Broadcast Products Technical Bulletin 20-2005-083

SUBJECT: REUSE PARTS WHEN REPLACING BK BOARD

MODEL: **BVM-1315**
BVM-1415P
BVM-1915
BVM-2015P

Figure 1

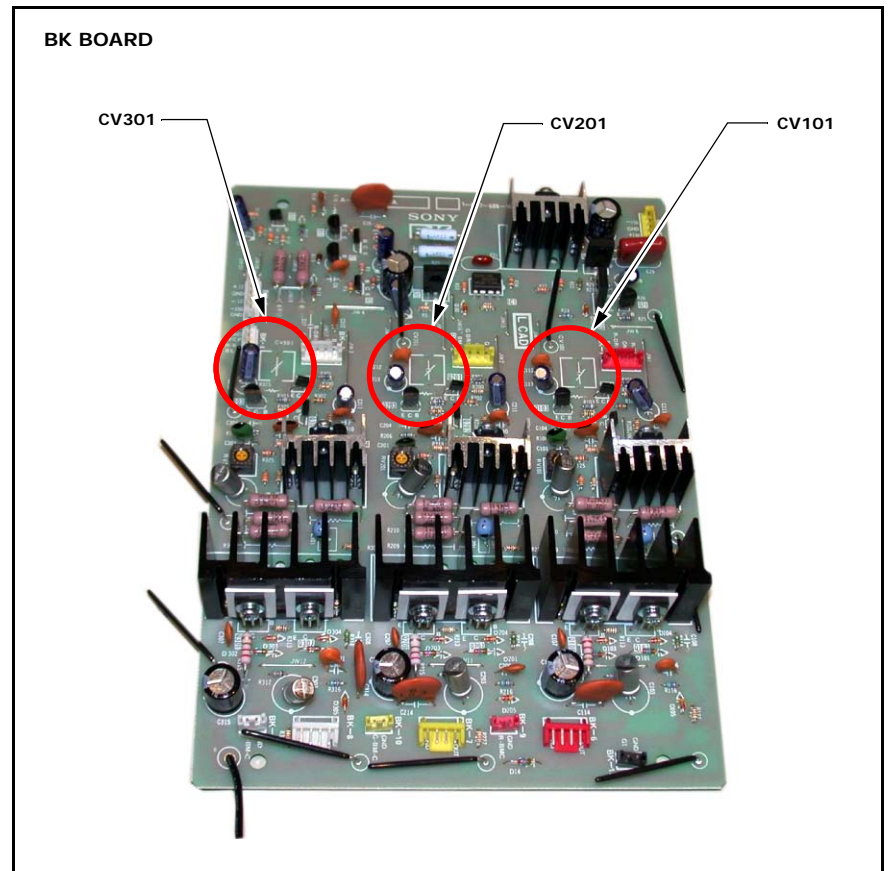
When you replace the BK board (A-1135-523-A), remove the following parts (TRIMMER 15P CAP, 1-141-180-13) from the former board and install them on the new board.

CV101
 CV201
 CV301

The new BK board does not contain the parts, and the parts are no longer available. (See Figure 1.)
